Product Change Notification: MFOL-08PRDK601

CCB 7597 Initial Notice: Qualification of MTAI as a new assembly site for WINCS02IC-TRAY, WINCS02IC, WILCS02IC-I/ZZX, WILCS02ICT-I/ZZX, WINCS02IC-I1/ZZX, WINCS02ICT-I1/ZZX, WINCS02IC-I/ZZX, WINCS02ICT-I/ZZX, WINCS02IC-V/ZZX, WINCS02ICT-V/ZZX, WILCS02IC-V/ZZX, and WILCS02ICT-V/ZZX catalog part numbers (CPN) available in 48L VFQN (7x7x0.9mm) package.

PCN Status: Initial Notification

PCN Type: Manufacturing Change

Pre and Post Change Summary – Lead frame Design

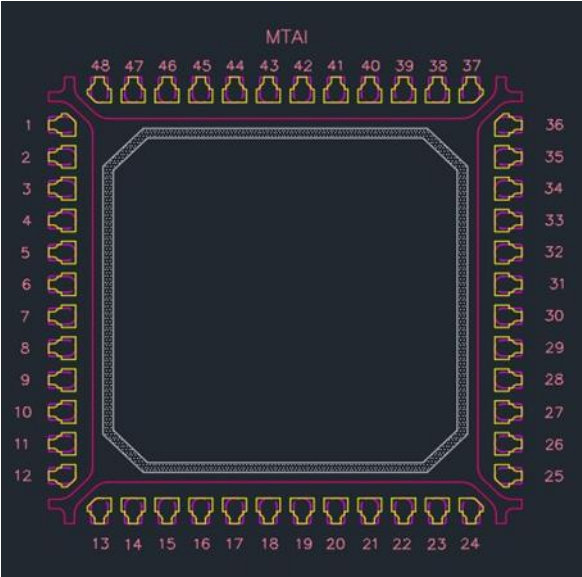
ASCL	MTAI				
 The ASCL lead frame diagram shows a square package with a central square cavity. The top edge has pins numbered 48 to 37, the bottom edge 13 to 24, the left edge 1 to 12, and the right edge 36 to 25. The frame is outlined in yellow and pink.	 The MTAI lead frame diagram shows a square package with a central square cavity. The top edge has pins numbered 48 to 37, the bottom edge 13 to 24, the left edge 1 to 12, and the right edge 36 to 25. The frame is outlined in yellow and pink.				
Note: Not to scale <table><tr><td>Lead-frame Material</td><td>C194</td></tr></table>	Lead-frame Material	C194	Note: Not to scale <table><tr><td>Lead-frame Material</td><td>A194</td></tr></table>	Lead-frame Material	A194
Lead-frame Material	C194				
Lead-frame Material	A194

Note 1: C194, A194 or CDA194 Lead frame material are the same, it is just a MCHP internal labelling difference.
